**JINDAL ALUMINIUM LTD.**  
**BANGALORE-560073 (INDIA)**

NAME	DATE
DRAWN	PARVESH	29-01-2013
CHECKED		
APPROVED	S.S.GARG	29-01-2013
SCALE		1:1
AREA mm <sup>2</sup>		1965.38
PERIMETER mm.		503.911
WEIGHT kg/m		5.307
DRAWING No.	SECTION No.	
P-11795	-	
13528	13528 (ISSUE-3)

PARTY'S NAME	OWN USE
PARTY'S DRAWING No.	AS PER SPECIFICATION
ALLOY & TEMPER	HE9 WP
DESCRIPTION	ROUND TUBE

P-11795

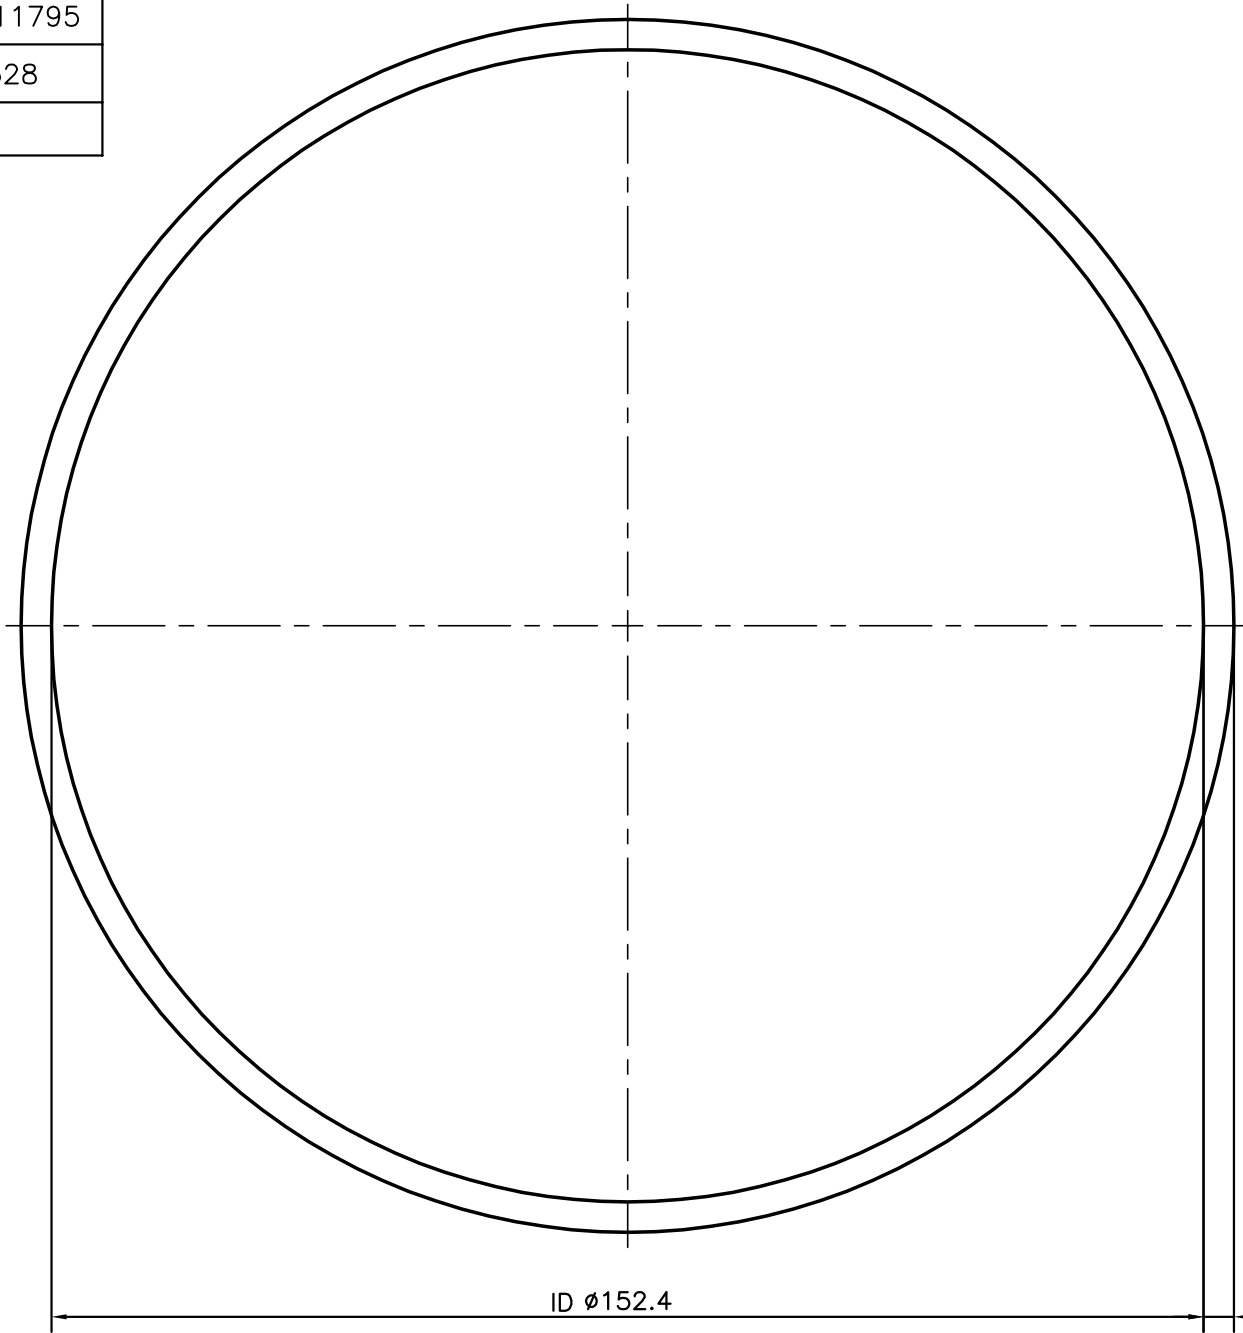
**ISSUE :- 2**

THICKNESS REDUCED FROM 3 mm. TO 1.5 mm. & WEIGHT ALSO CHANGED FROM 3.954 Kg/m TO 1.958 Kg/m.

**ISSUE :- 3**

THICKNESS INCREASED FROM 1.5 mm. TO 4 mm. & WEIGHT ALSO CHANGED FROM 1.958 Kg/m TO 5.307 Kg/m.
